SUBJECT: UNIVERSITY OF MISSOURI - ROLLA RESEARCH REACTOR (UMRR)  
FACILITY – ISSUANCE OF AMENDMENT NO. 20 TO FACILITY  
OPERATING LICENSE No. R-79 (TAC NO. MD6700)

AMENDMENT TO FACILITY OPERATING LICENSE

Amendment No.20  
License No. R-79

SAFETY EVALUATION BY THE OFFICE OF NUCLEAR REACTOR REGULATION  
SUPPORTING AMENDMENT NO. 20 TO  
FACILITY OPERATING LICENSE NO. R-79  
UNIVERSITY OF MISSOURI-ROLLA  
DOCKET NO. 50-123

Figure 6-1. Organizational structure of the University of Missouri related to the UMR Nuclear Reactor Facility.

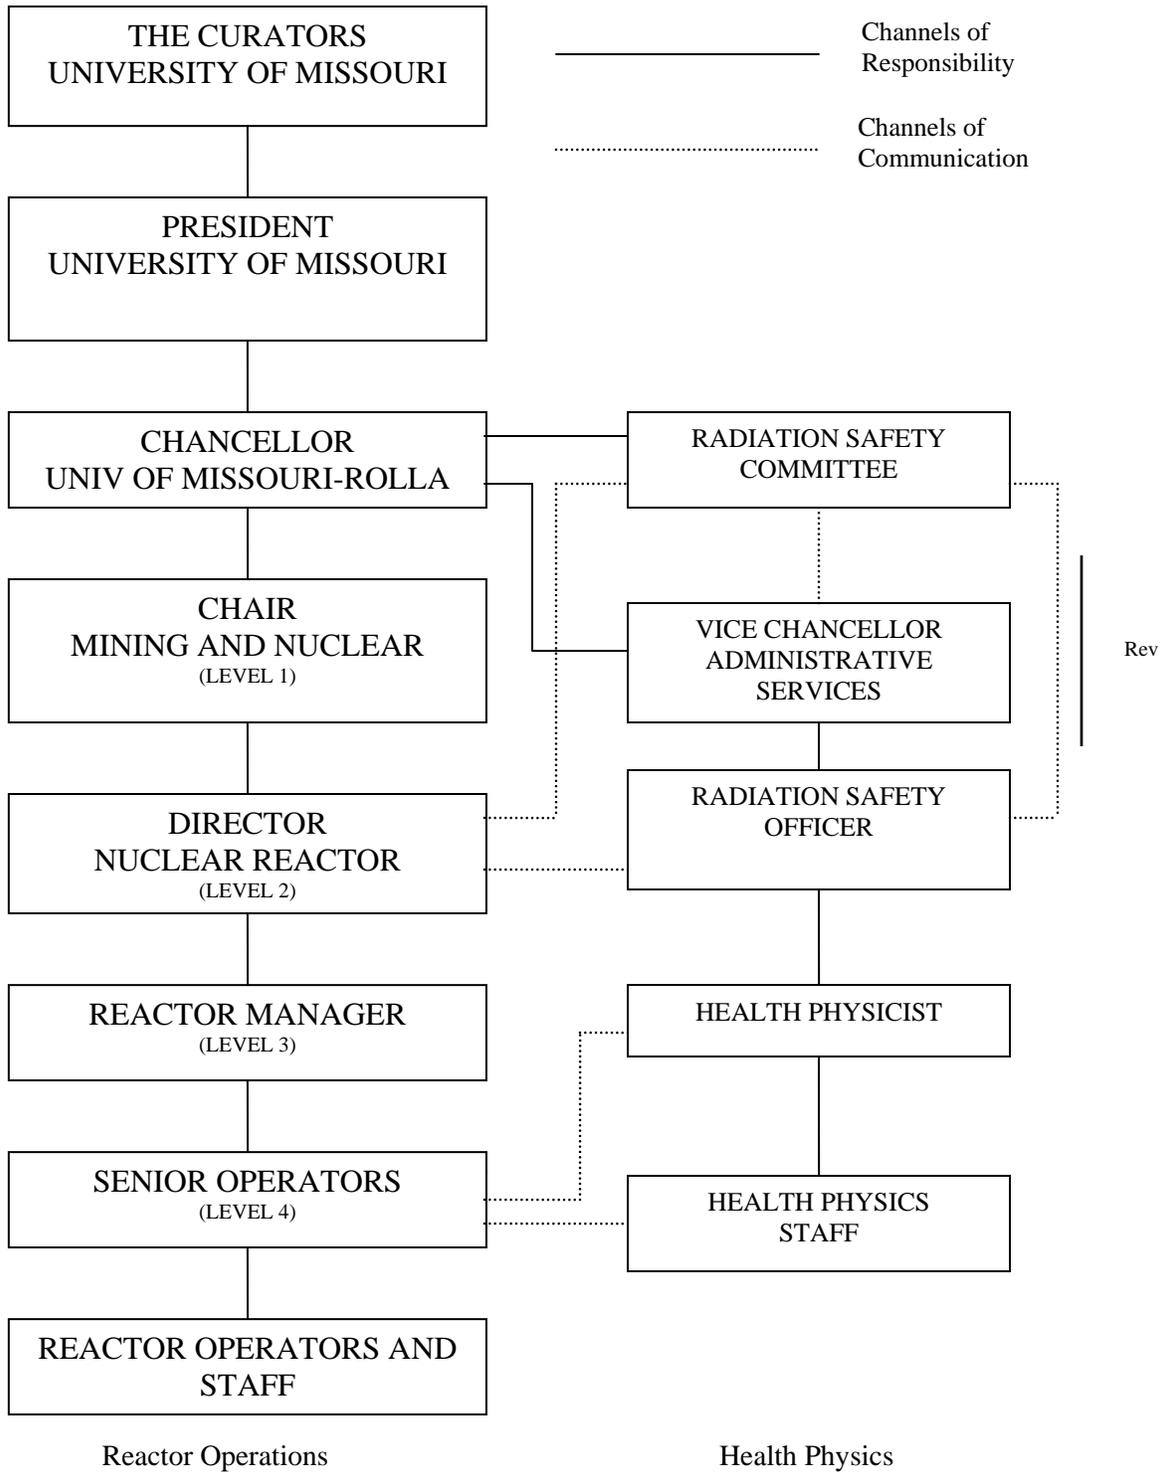
Figure 6-1 lists the Dean of School of Mines (Level 1) in the channels of responsibility.

The licensee has proposed to list "Chair Mining and Nuclear (Level 1)" in place of "Dean of School of Mines."

The Chair of Mining and Nuclear Engineering has replaced the position Dean of the School of Mines and Metallurgy as the Level 1 position. ANS 15.1 defines Level 1 positions as those responsible for the reactor facility's licenses. As a member of upper level university management the Chair of Mining and Nuclear Engineering fits this definition of Level 1 manager and this change is therefore acceptable to the staff.
